C•CURE 9000 Technical Assistance Bulletin

TAB number: SWH-TAB-000035806

Topic: iSTAR Ultra G2 ACM Fire Alarm Interlock (FAI) relay drive logic change

Figure 1: Normally energized checkbox

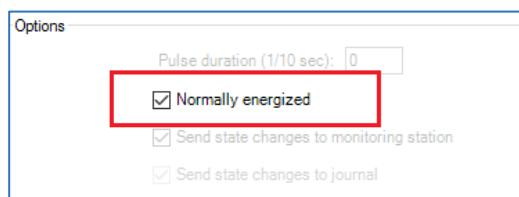
Software House updated the Fire Alarm Interlock (FAI) relay drive logic on iSTAR Ultra G2 ACMs to align with industry standards.

iSTAR Ultra G2 FAI behavior: FAI-enabled relays deactivate and are disabled if FAI activation occurs when the F (fire) input of J84 opens (J84 is NC – normally closed).

iSTAR Ultra G1 FAI behavior: FAI-enabled relays activate if FAI activation occurs.

- **C•CURE:** In the iSTAR Output Editor in C•CURE, outputs must be set to Normally Energized for any FAI-enabled relays as shown in Figure 1 below. Refer to the *Configuring iSTAR Controllers* chapter in the *C•CURE Hardware Configuration Guide* for more information.
